NUCLEAR REGULATORY COMMISSION

In the Matter of: ADVISORY COMMITTEE ON REACTOR SAFEGUARDS
SUBCOMMITTEE ON DECAY HEAT REMOVAL SYSTEMS

DATE: March 16, 1982 PAGES: 1 - 302

11 The purpose of the meeting is to discuss the
12 status of Task Action Plan A-45, the effectiveness of the
13 feed and bleed heat removal processes, and the
14 Combustion Engineering response to the ACRS comments on
15 the CESSAR System 80 decay heat removal systems.

Figure 1. Inter-Relation of Sub-Tasks in Task Action Plan A-45 - (Oct. 1982)

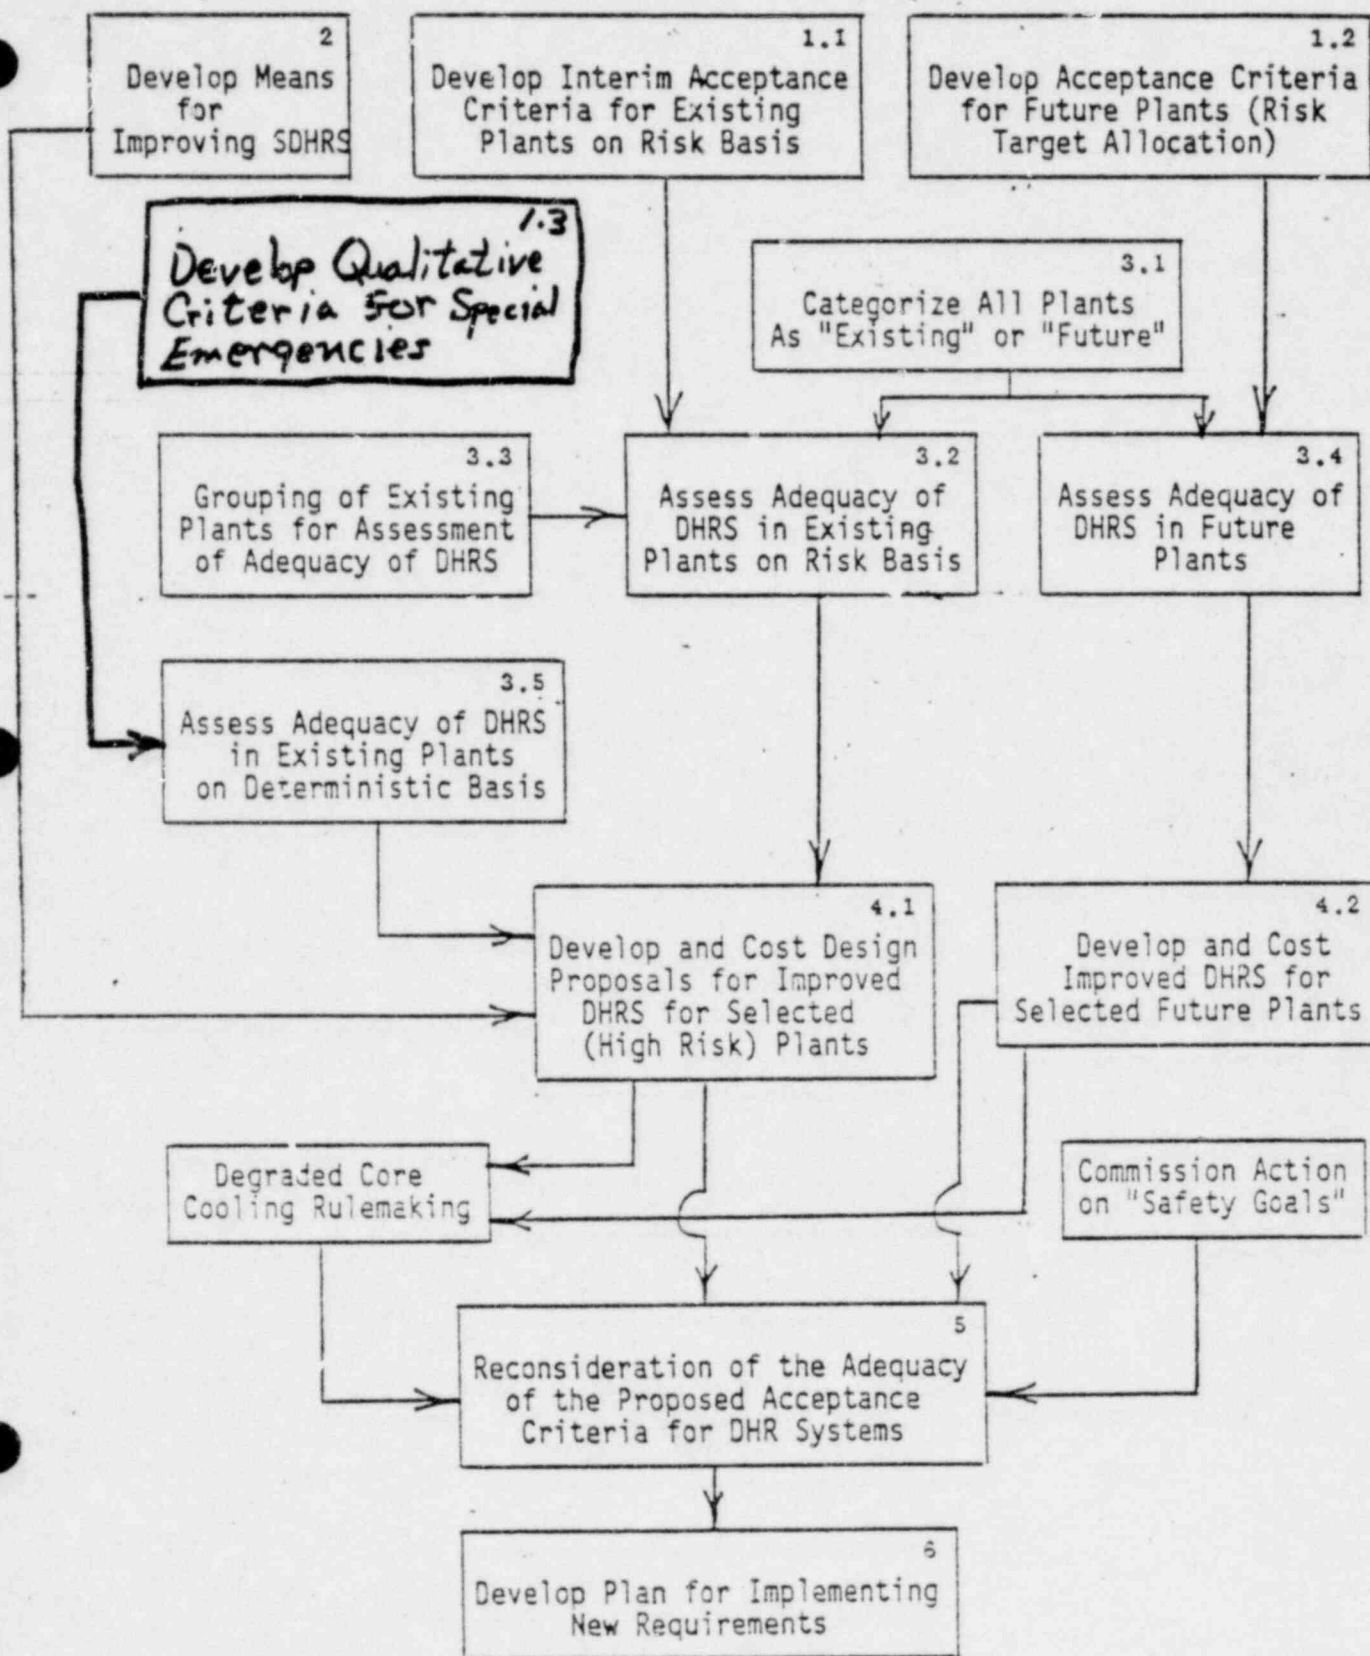
8 In terms of how these tasks interrelate, that
9 is shown here. You can see this is much simpler than
10 the previous diagram on the plan. We are going to be
11 starting off with developing criteria, as well as with,
12 in parallel with that, needs for improving decay heat
13 removal systems.

3 MR. ZUDANS: That means they already have
4 overcome the question that I asked with respect to this
5 third item. What did they pick as the rest of the plant
6 to match this improved decay heat removal system to? You
7 can't just take this system itself and make a judgment
8 on its merits. You have to look at the rest of the
9 plant as well. So they must have picked some plant to
10 gauge the systems on.

14 MR. ZUDANS: It means -- in response to my
15 question, this part is already done?

11 MR. MARCHESE: That's right. They picked some
12 plant. I'm not sure I'm at liberty to discuss that. I
13 think there was an agreement not to.
